# APE SERVICE BULLETIN

# #49 CLAMP PRESSURE TRANSDUCER UPDATE

Upgrading your power unit to a pressure transducer from a pressure switch

Image 1.

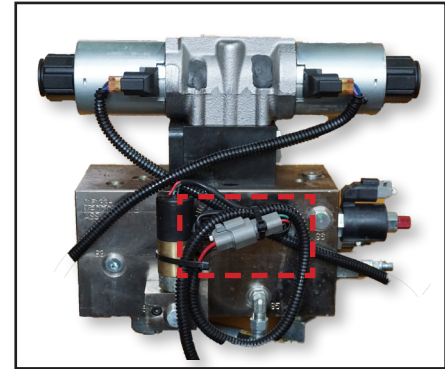
- Latest software update (downloaded from Vault) See Service Bulletin # 52 to load software.
  - Unplug existing 3-pin Deutsch pressure switch on the clamp manifold, (See image 1)

Image 2.

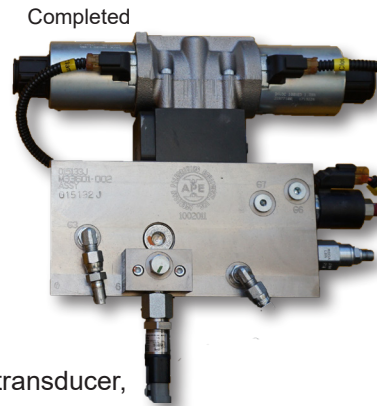
- Remove the existing 3-pin Deutsch connector from main wiring harness, (flying leads)
  - Insert black wire in position 4 on 4 pin male Deutsch connector (See image 2)

- Insert blue/white wire in position 1 on 4 pin male Deutsch connector. (See image 2)
  - Insert red wire in position 2 on 4 pin male Deutsch connector. (See image 2)

Image 3.

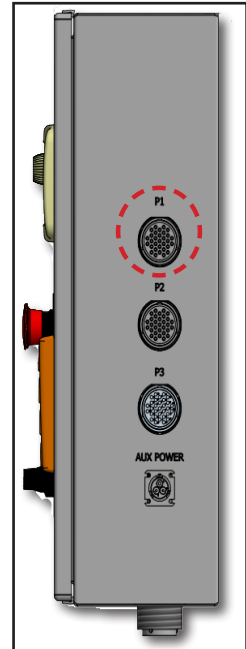
- Install orange keeper
  - Route the blue/white wire into existing wiring harness to the control panel into plug P1 (See image 3)
  - Remove white plug in position 1, plug 1, insert blue/white wire into position 1, plug 1
